**OLD WOOD ENERGY PARK
APP REF: 24/00161/FUL
ECOLOGY RESPONSE NOTE**

This Ecology Response Note has been written in response to comments received by the Council's Ecologist and the Nottinghamshire Wildlife Trust dated the 30th May 2024 and 12th April 2024 respectively, as part of consultation on the planning application for Old Wood Energy Park (application reference: 24/00161/FUL), which is for the construction, operation and subsequent decommissioning of a renewable energy park comprising ground mounted Solar PV with co-located battery energy storage system (BESS) at the point of connection, together with associated infrastructure, access, landscaping and cabling (the proposed development). The Development is located on land north of Wysall Road (the southern parcel, which includes part of the solar farm, the substation and the BESS) and land west of Bradmore Road (northern parcel, which includes the rest of the solar farm).

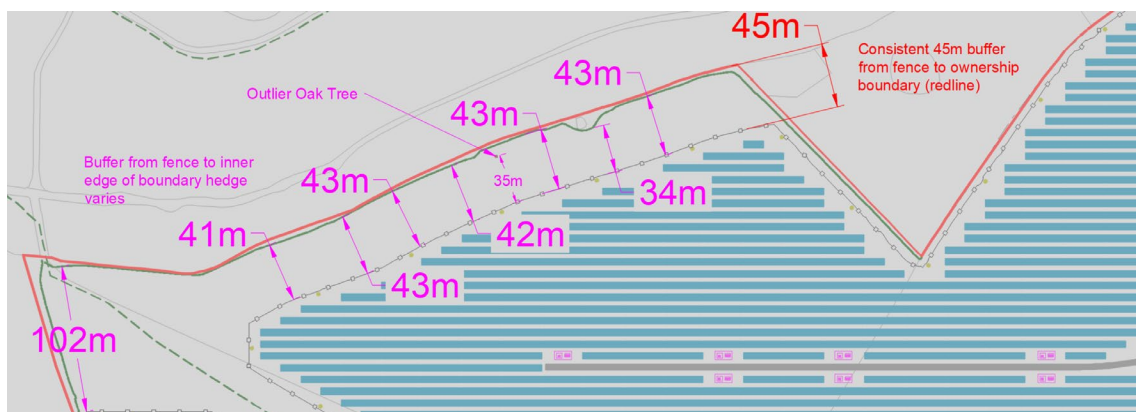
In relation to a 15m development buffer being appropriate, if the application were to be approved, we feel there is a strong argument for a significantly wider woodland buffer in this location, as was included in the layout for adjacent approved Highfields Farm application. We also wish to highlight the 15m is a minimum, with the guidance stating. The reasons why we are taking this standpoint in relation to a requirement for a much wider buffer zone is set out below.

The image below illustrates the maximum and minimum offset distances along northern boundary, adjacent to Bunny Old Wood. As can be seen this ranges from 35 m at the closest to 43 m. This distance is also to the fence with the solar panels at least a further 5 m inside. This is considered to be a significant and substantial buffer of the ancient woodland, and significantly greater than the minimum 15 m.

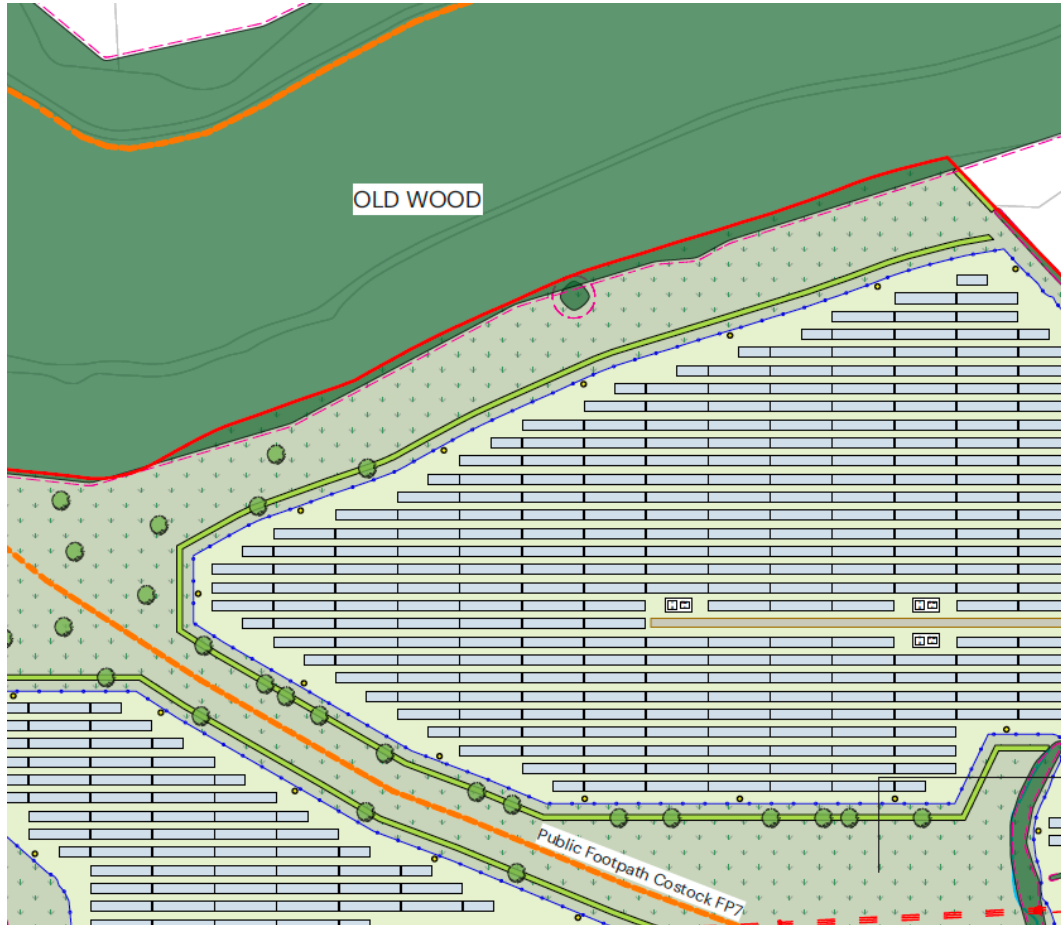
As 40m is a cited height of a mature ash tree, we would recommend that a margin of more than 30m is established between the woodland and proposed boundary fencing, to protect the fence and any other valuable equipment and infrastructure, such as panels, in the event of any large trees coming down in the future, should the application be approved.

As detailed above, the provided image illustrates the maximum and minimum offset distances along the northern boundary, adjacent to Bunny Old Wood. This ranges from 35 m at the closest to 43 m. this distance is also to the fence with the solar panels at least a further 5 m inside. As a result the above request is met and there is not likely to be any impact on the Development as a result of tree fall from ash die back, should that occur along the northern boundary.

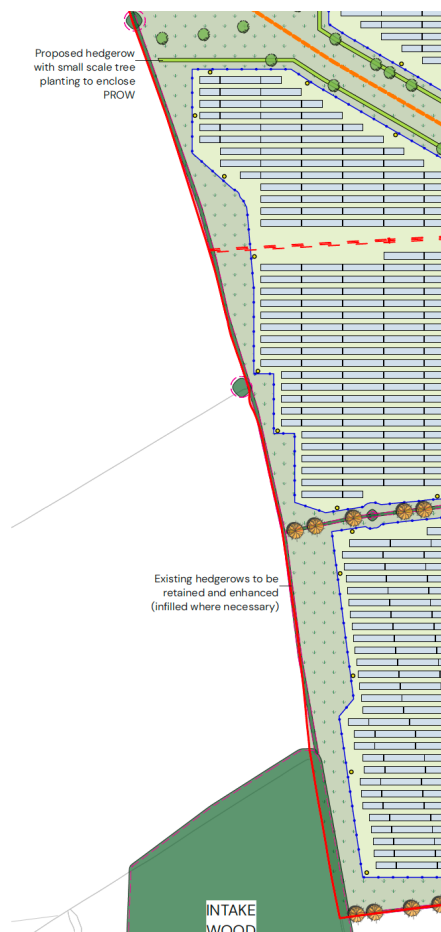
Recommendation 3 – strengthening north south orientated woodland linkages (between Kingston Brook t bunny Wood, via Copses and proposed hedgerow planting along PROW) along western boundary

The written comments from NWT were provided before a site visit between Exagen and NWT where it was confirmed, that as shown on the Phase 1 Habitat Plan in the EclA, that there was an existing hedge with trees in the location indicated between Rough Plantation and the new proposed copse and woodland planting near the centre of the northern parcel. It is therefore not considered necessary to provide any additional hedgerows in this location as originally requested by NWT (first sketch above). This existing hedgerow and the grassland buffer between it and the fenceline will provide a substantial green corridor, approximately 20 m wide.

It is not possible to accommodate the proposed woodland planting to the north and south of Long Plantation (second sketch above) as a result of direct loss of a large number of solar panels but also potential shading effects, however it should be noted that there are existing hedgerows and trees between the new east west copse planting on the southern boundary and Long Plantation and also between Long Plantation and Wysall Rough Plantation so there is already a good north – south green corridor/ network. The Landscape Strategy looks to enhance these on east-west alignments east of Long Plantation and Wysall Rough plantation. Under recent amendments to the design the western fence line has been adjusted with the loss of a very small number of panels and this has resulted in a larger offset between the existing vegetation and the fence to be used as a green corridor. The original layout had a 5 m corridor with the fence offset from the hedge but the revised plan the fence is offset from the solar panels to increase the space outside the fence. Typically this is now around 15 m wide (ranging between 7 m and 25 m south of Long Plantation and ranging between 10 m and 17 m north of Long Plantation). The following two extracts illustrate this but reference should be had to the Landscape Strategy and Green Infrastructure Plan.

In addition to the above changes, during the site visit with the NWT further amendments were discussed to the western boundary of the northern parcel to enhance the green corridor/ network between Rough Plantation/ Intake Wood and Bunny Old Wood. The fence line has also been adjusted in places resulting in the loss of a very small number of solar panels but allowing for a greater amount of land outside of the fence which would be planted as a wildflower meadow mix providing greater value habitat and of a width more useful as a green corridor connecting Rough Plantation/ Intake Wood with Bunny Old Wood. This is typically around 20 m wide but ranging from 6 m at the narrowest pinch point and extending to 33 m at the widest point
